## P/N\_171-0890-00\_CVR\_PT005019

### 1.0 Alternated components in M/B (670-1401-02)

With regard to P/N\_171-0890-00 in M/B (670-1401-02):

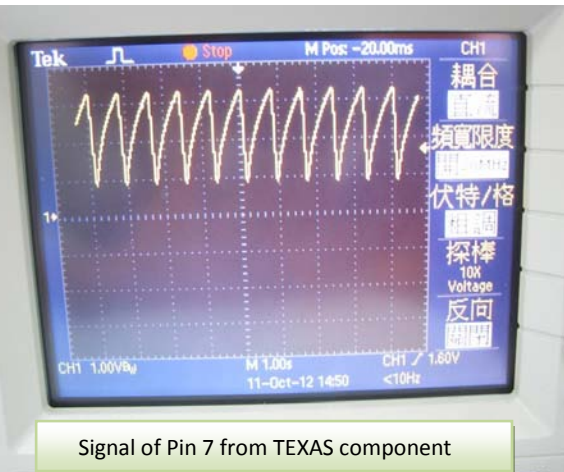
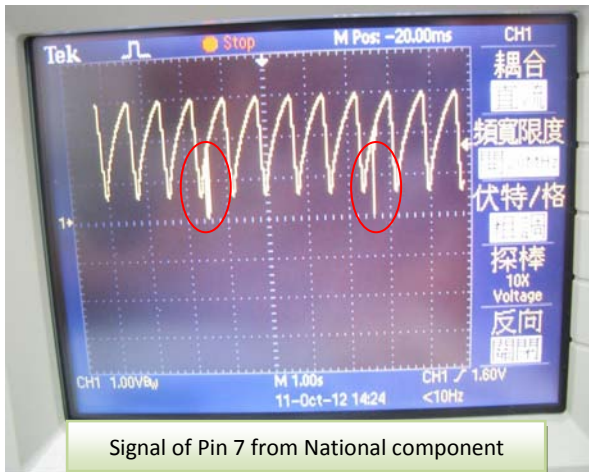
3.1 For pin 1: compared with TEXAS component, there obviously has the interference signal in National part.

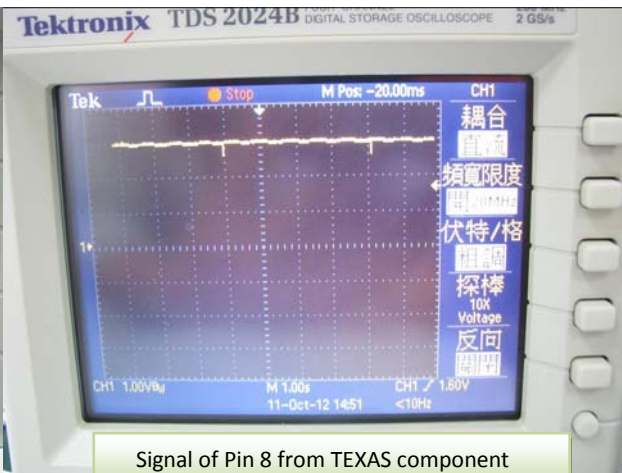
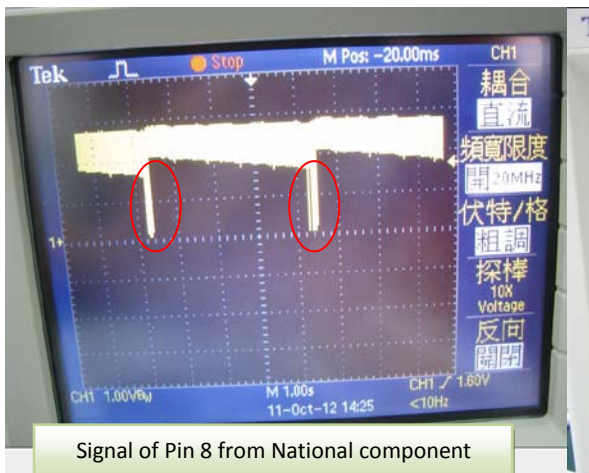
3.2 For pin 7: compared with TEXAS component, there obviously has the interference signal in National part.

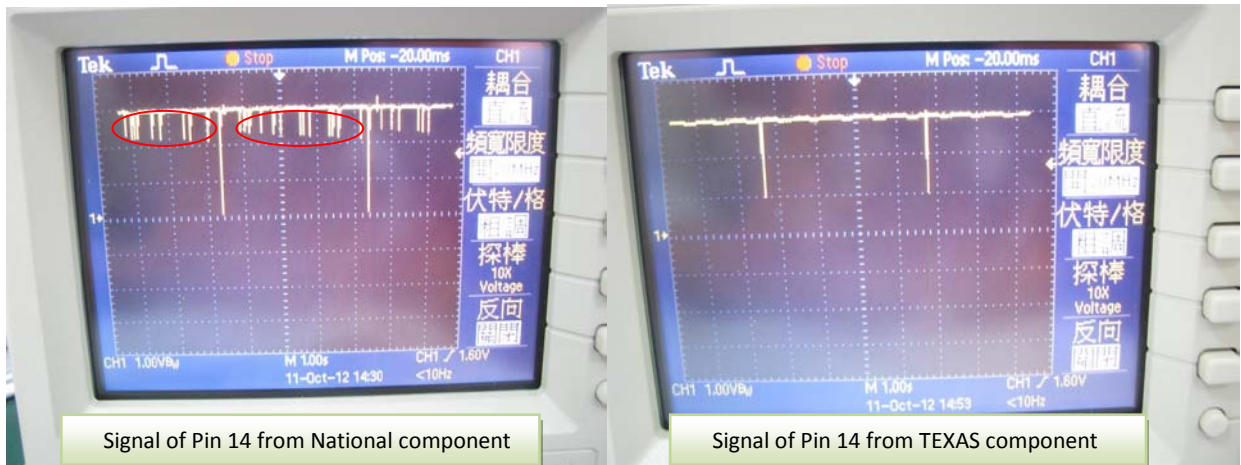
3.3 For pin 8: compared with TEXAS component, there obviously has the interference signal in National part.

3.4 For pin 14: compared with TEXAS component, there obviously has the interference signal in National part.
